From: Aphrodite Ioannidou
Sent: 16 January 2023 20:16
To: Planning Planning
Cc: Neil McDonald
Subject: 112A Great Russell Street, London WC1B 3NP - Application ref: 2022/5446/P

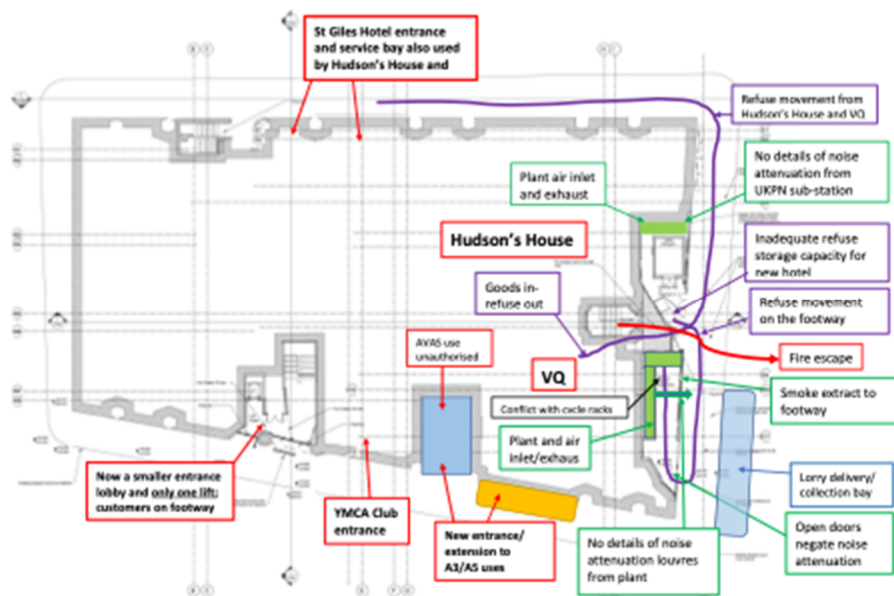
The TPP Reports do not take into account multiple deliveries/ removals happening simultaneously. No management agreement will resolve this. See diagram below.
